COBAR CONSOLIDATED RESOURCES LIMITED

Response to a Request of NSW
Office of Water for Additional
Information
Issued on 8 February 2011

WONAWINTA SILVER PROJECT

March 2011

Figure A	Potentially Impacted Waterways.....	4
Figure B	Indicative Groundwater Monitoring Plan.....	9

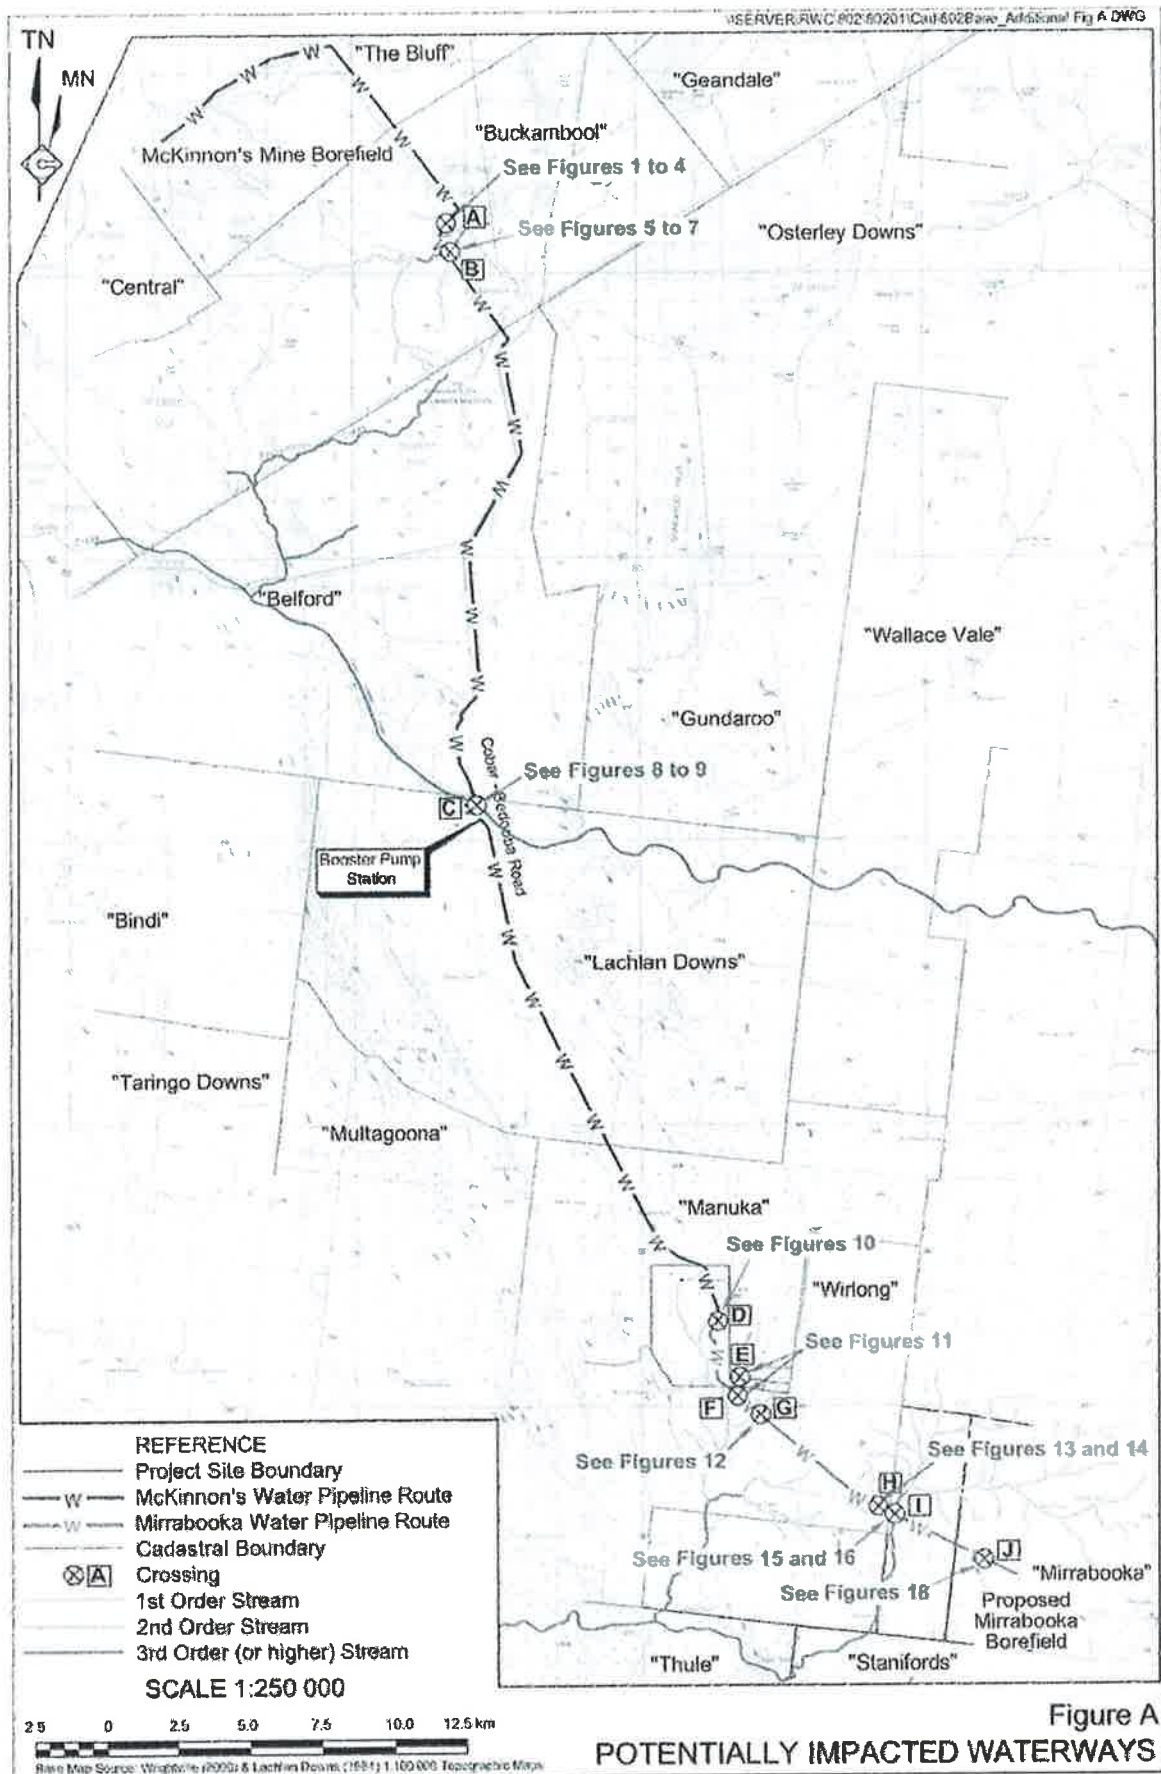
"As detailed in the EIS a Controlled Activity Approval may be required under the Water Management Act 2000 for the activities of 1) pipeline crossing of watercourses, and 2) culverts and waterway crossings. To confirm if an approval is required and to determine general terms of approval where necessary the following information is requested:

- Provide a map of suitable scale with the locations of proposed works within 40m of a watercourse clearly marked. As a starting point a watercourse can be defined as a blue line on the relevant topographic map.*
- Confirm land ownership of each proposed work.*
- Provide photographs of each location to represent the area of proposed works and the adjacent area which may be impacted.*
- Description of works at each location, this is to include a design of the works and the requirement for excavation and disturbance at each site.*
- An assessment of the impact of each of the works and outline the necessary management and mitigating measures.*

With reference to the 1:50 000 scale topographic maps of the area, the potential water courses identified by blue lines along the alignment of the McKinnon's Pipeline Route, Project Site and Mirrabooka Pipeline Route were inspected. **Figure A** provides the locations of those watercourses (and stream order based on the topographic mapping) considered to carry water (although on most occasions the flow of water would be more akin to sheet flow than channelized flow). **Figures 1 to 18** (of **Attachment 1**) provide photos of each of the water courses.

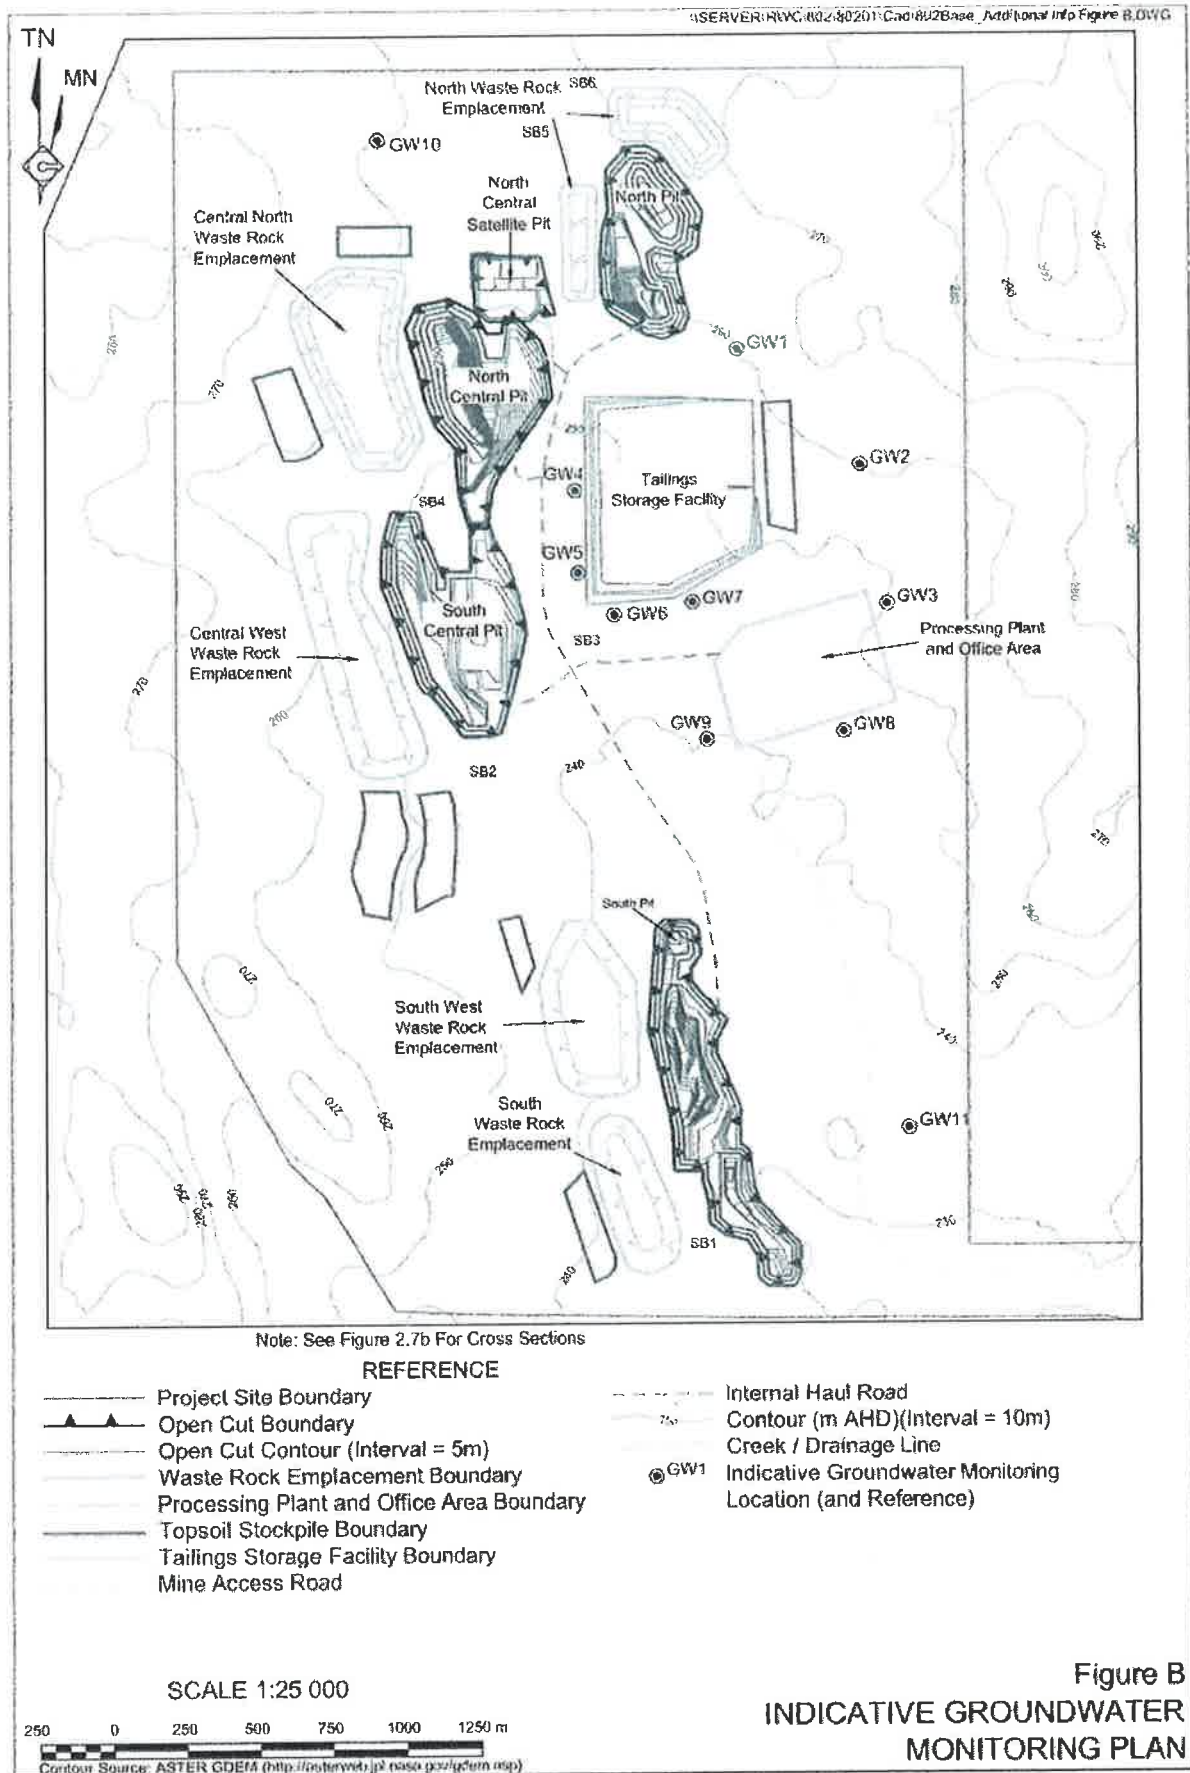
"The Office advises that monitoring bores must be licensed under the Water Act 1912 and there is currently an exemption in the NSW Inland Groundwater Shortage Zones Embargo which allows for applications to be made for this purpose. It is expected that the number and location of monitoring bores will not be finalised until finalisation of the groundwater management plan, hence any GTAs issued for this type of licence will need to require further detail upon application of the licence/s. The proponent will need to ensure that all existing monitoring bores are licensed under the Water Act 1912.

The Applicant acknowledges the requirement to licence monitoring bores, the locations of which will be determined as part of the preparation of a Groundwater Management Plan for the Project. The Applicant has committed to consulting with NOW in the development of a Groundwater Management Plan. **Figure B** provides an indicative illustration of proposed groundwater monitoring bore locations.
